Access Compliance Report

Public Rights-of-Way

Intersection ID: 53165	Main Street: DIXIE_RIVER_RD	Cross Street: N/A	Location: SW
ADA ID: 8C4B61B5A0B0	Ramp Type: Perp	Initial Pass/Fail: Fail	Overall Compliance: No
		Severity Score: 12.5

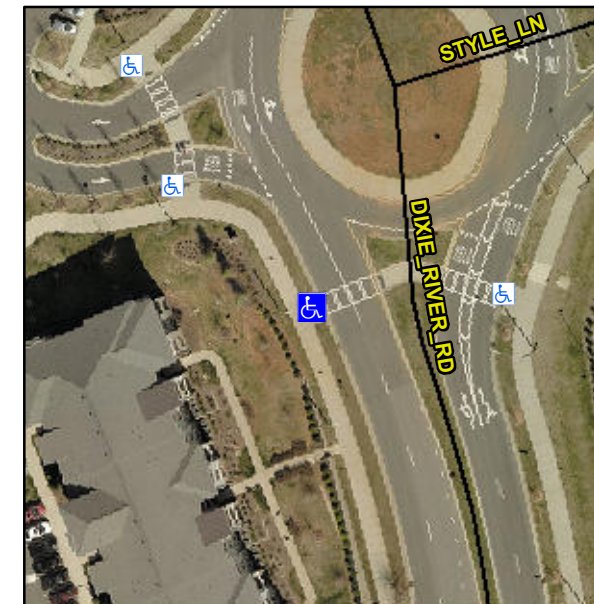
Not Found, R304.5.3

Compliance	Description	Data	Compliance	Description	Data
N/A	Ramp Length (in)	96.0	Yes	Ramp Slope (%)	7.9
Yes	Ramp Width (in)	48.0	No	Ramp XSlope (%)	6.7
N/A	Flare Type LT	N/A	N/A	Flare Type RT	N/A
N/A	Flare Slope LT (%)	N/A	N/A	Flare Slope RT (%)	N/A
N/A	Flare Traversable LT?	N/A	N/A	Flare Traversable RT?	N/A
N/A	Landing Length (in)	N/A	N/A	DWS Provided?	N/A
N/A	Landing Width (in)	N/A	N/A	DWS Contrast?	N/A
N/A	Landing Slope (%)	N/A	N/A	DWS Length (in)	N/A
N/A	Landing X Slope (%)	N/A	N/A	DWS Full Width?	N/A
N/A	Landing Curb? (Y/N)	N/A	N/A	DWS Offset (in)	N/A
N/A	Shared Landing?	N/A			
N/A	Gutter Ponding?	N/A	N/A	Gutter Slope (%)	N/A
N/A	Gutter Lip Ht (in)	N/A	N/A	Gutter X Slope (%)	N/A
N/A	Painted X Walk1?	Yes	N/A	Painted X Walk2?	N/A
	X Walk 1 Direction	To E		X Walk 2 Direction	N/A
N/A	X Walk 1 Width (in)	115.0	N/A	X Walk 2 Width (in)	N/A
	X Walk 1 Slope (%)	2.5		X Walk 2 Slope (%)	N/A
	X Walk 1 X Slope (%)	5.6		X Walk 2 X Slope (%)	N/A

Remove & Replace Entire Ramp.
